HIGH PLAINS FILING NO. 1

CONSTRUCTION DOCUMENTS

PCD FILE NO: SP-18-003
SF-18-024

REV.	DESCRIPTION	DATE
1	ADDRESS AGENCY COMMENTS	09/27/18

HIGH PLAINS FILING NO. 1
GRADING & EROSION CONTROL PLAN

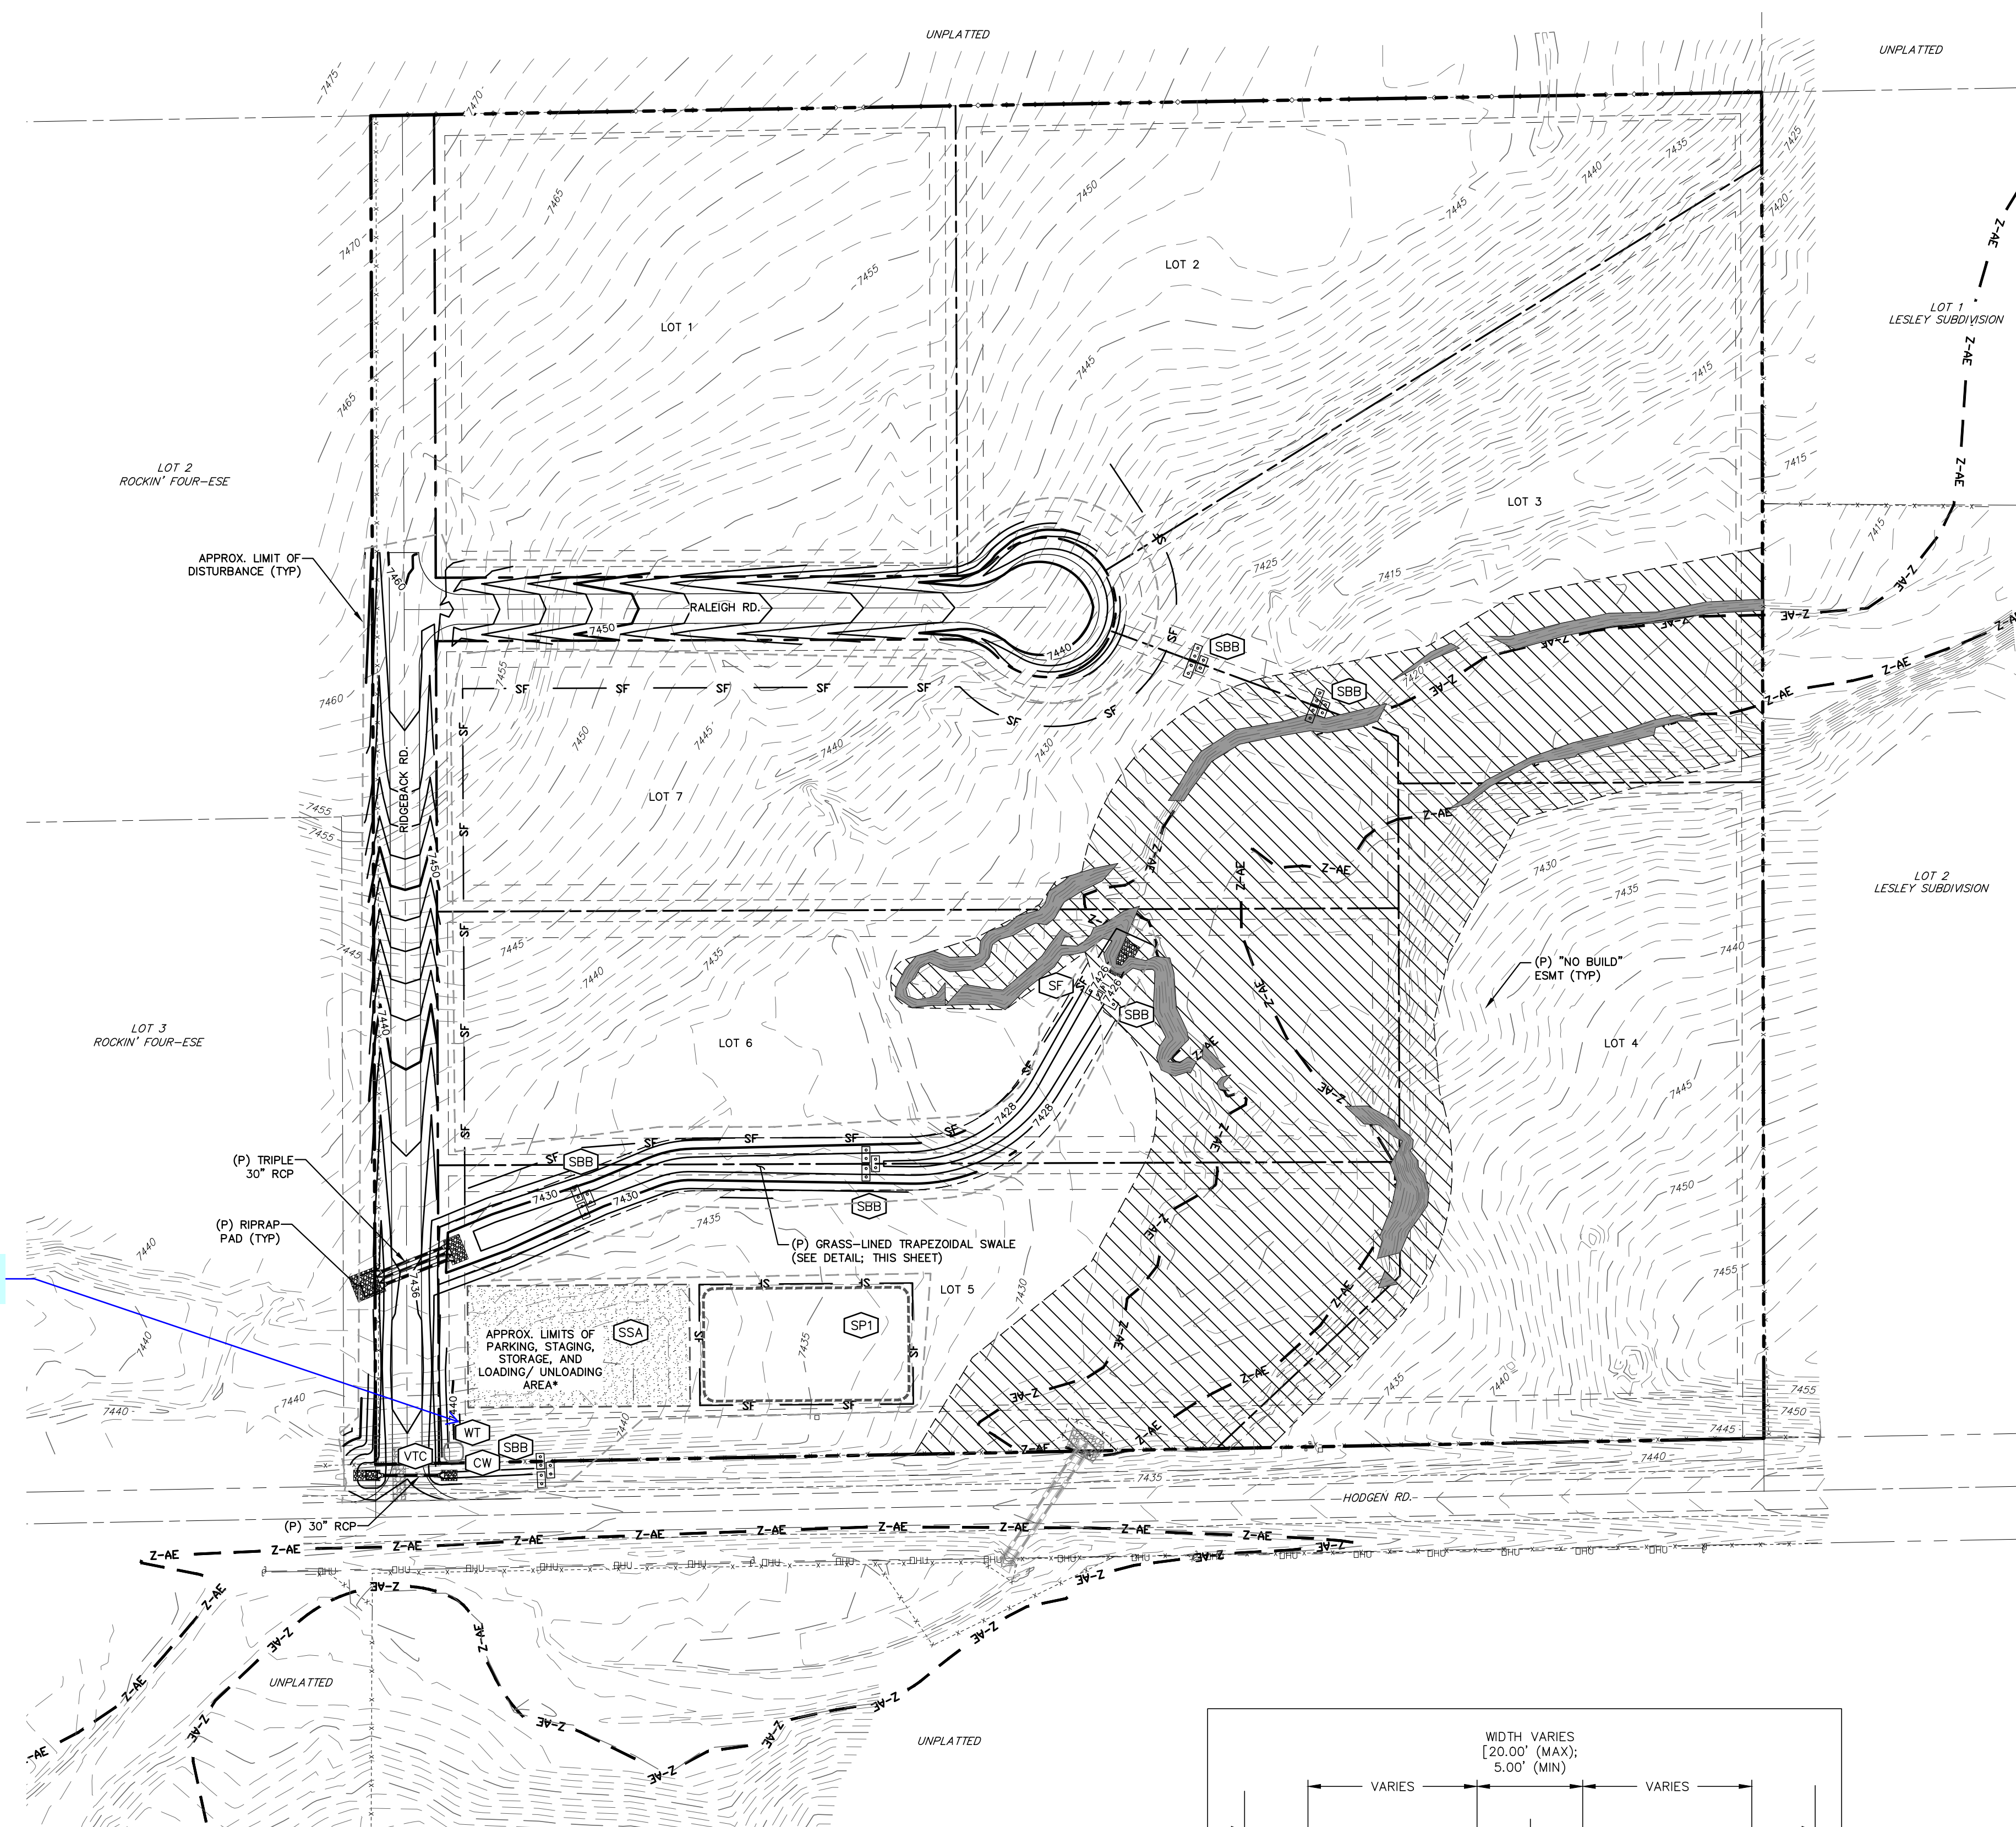
Add this BMP to the legend

Provide detail for Straw bales

HIGH PLAINS FILING NO. 1
 RIDGEBACK ROAD
 STREET IMPROVEMENT
 PLAN & PROFILE

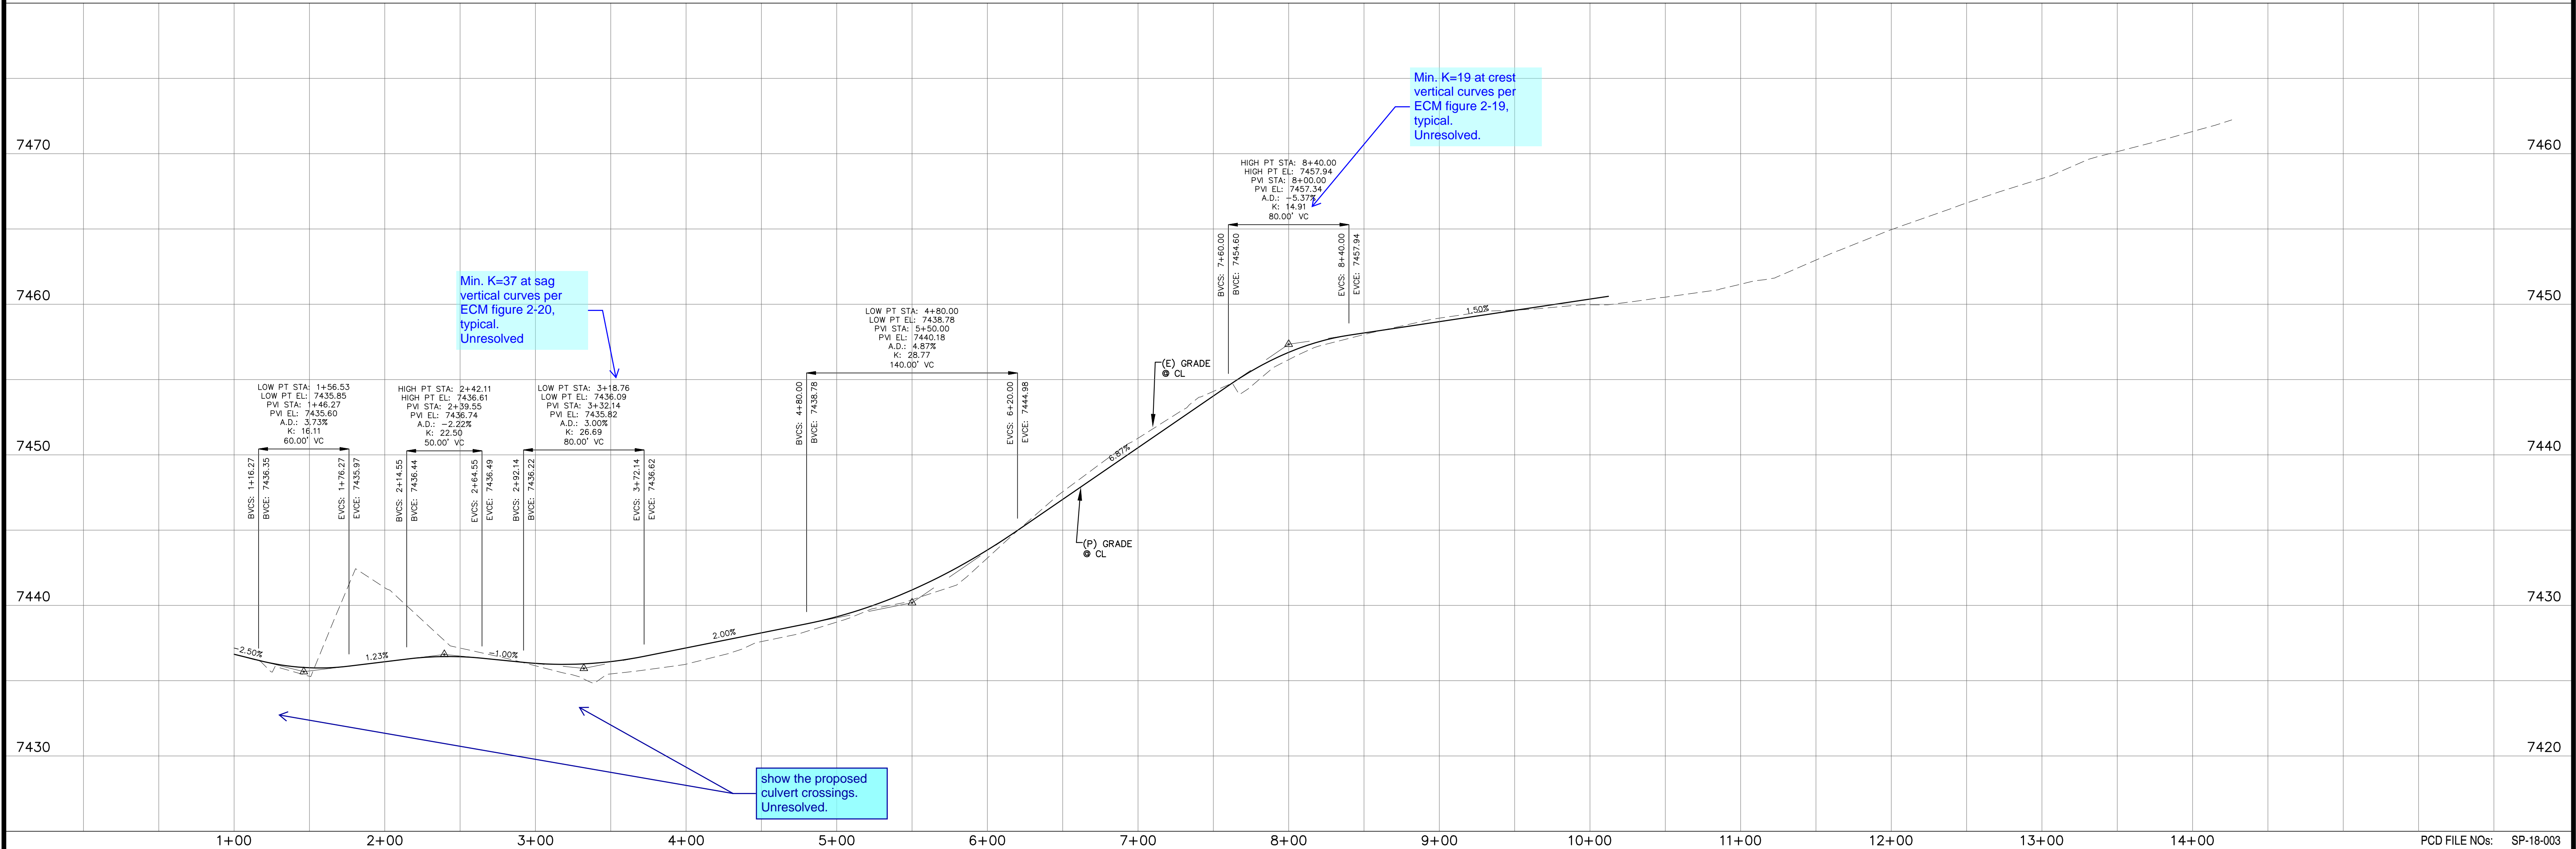
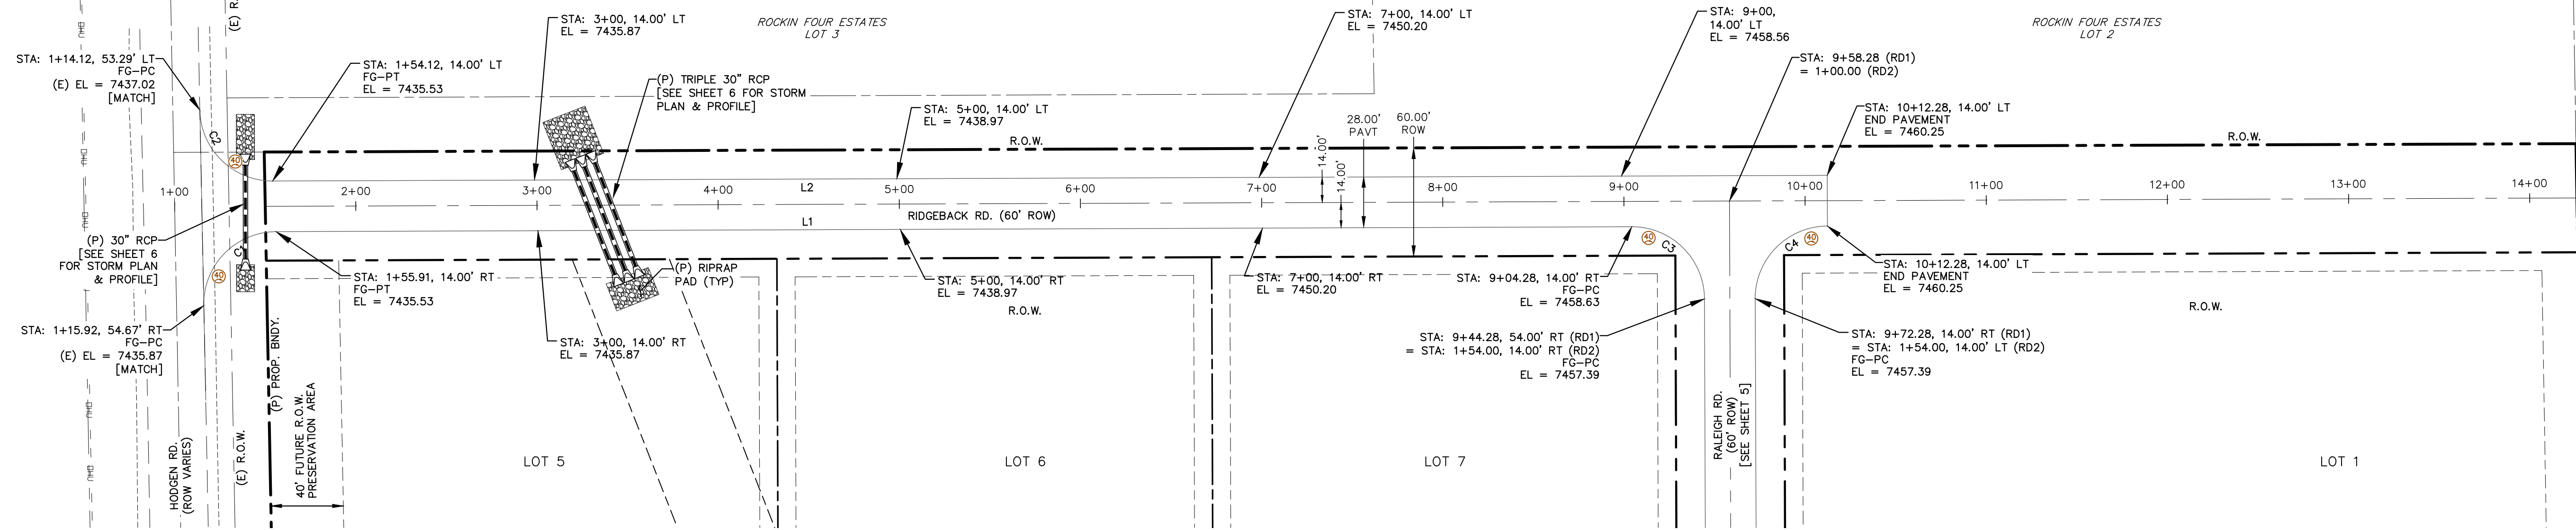
Review 1 comment partially resolved.
 Review 2: Include road classification i.e. Ridgeback Road - Rural Local

show the proposed culvert crossings. Unresolved.
